**RE: DISAPPROVAL
SWMU-1 INVESTIGATION REPORT
WESTERN REFINING SOUTHWEST INC., GALLUP REFINERY
EPA ID # NMD000333211
HWB-WRG-20-010**

**RE: APPROVAL WITH MODIFICATIONS
OW-61 THROUGH OW-65 WELL INSTALLATION REPORT
WESTERN REFINING SOUTHWEST INC., GALLUP REFINERY
EPA ID # NMD000333211
HWB-WRG-19-020**

RE: Response to Approval with Modifications
Investigation Work Plan Solid Waste Management Unit 1
Marathon Petroleum Company LP, Gallup Refinery
(dba Western Refining Southwest, Inc.)
EPA ID# NMD000333211

**RESPONSE TO APPROVAL WITH MODIFICATIONS SWMU-1 SOIL
SAMPLING INVESTIGATION WORK PLAN**

FIGURE 3a

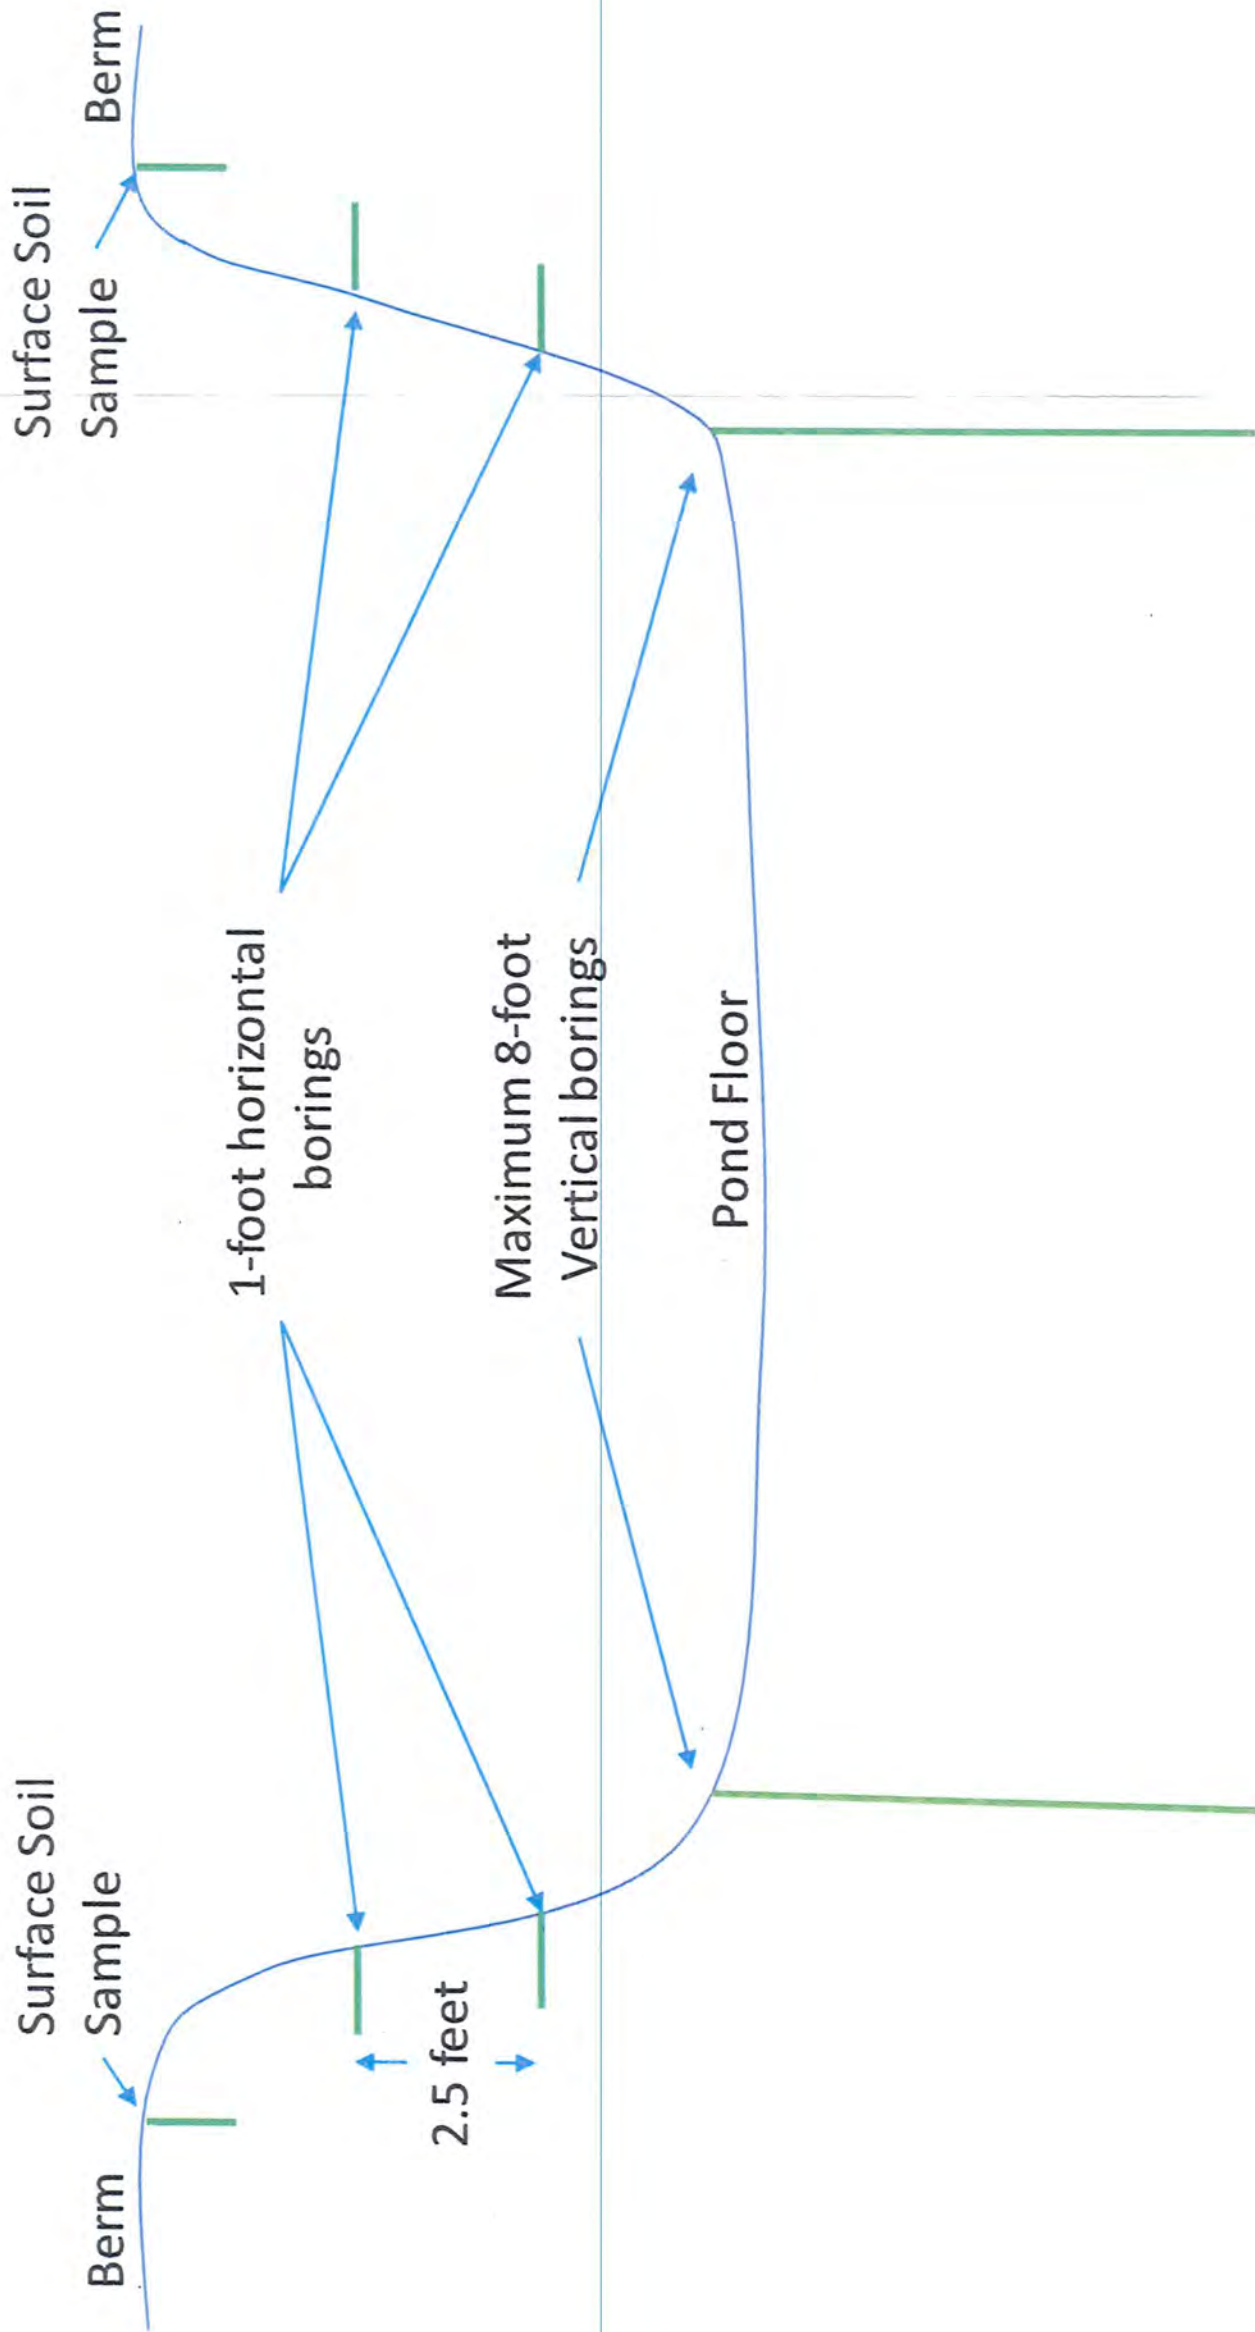
Under the heading "Investigation Methods", the Permittee states, "[s]oil samples will be collected by hand-augering within SWMU 1 and along the perimeter sidewalls (Figure 3). Discrete sediment samples will be collected at 2.5-ft intervals from the surface until visual and/or instrumental contamination is no longer evident, or until a maximum depth of approximately 8 feet is reached." The Permittee does not specify if the berm sidewall samples will be collected using a hand auger or with a different tool and does not specify to what depth/horizontal position the berm sidewall samples will be collected. Provide this information in a response letter.

SWMU 1 sidewall soil samples along the berm will be collected using a hand auger. The first sample will be collected from the top surface of the berm and advanced 1-foot vertically into the berm. The next sample will be collected approximately 2.5-foot below the top of the berm (Figure 3a) and advanced 1 foot horizontally into the berm side wall. Additional samples will be collected approximately at 2.5-foot intervals until the toe of the berm is reached. Samples at the toe of the

berm will be collected vertically from the surface, at 2.5-foot intervals to an 8-foot maximum depth or until visual staining and/or no instrumental response is detected (Figure 3a). A sample will also be collected from any saturated intervals.
